# **Drainage and Transportation Design Criteria Manuals Update**

**Chad Allen/Pritam Deshmukh – Capital Projects**

**March 20, 2018**

Figure 1.3.2 Two Lane Collector Options

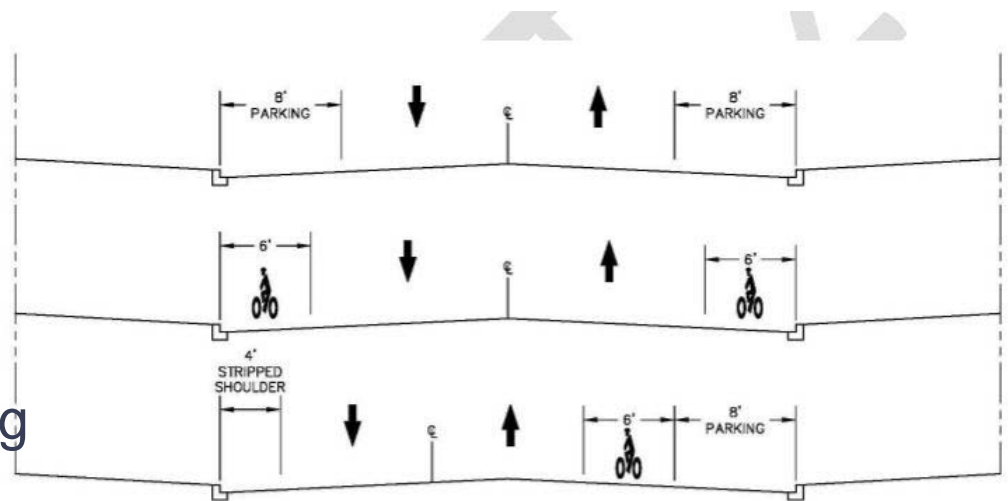
- ▶ Street Section Flexibility
  - ▶ Option 1 – High Parking Demand
  - ▶ Option 2 – Low Parking Demand
  - ▶ Option 3 – Medium Parking Demand
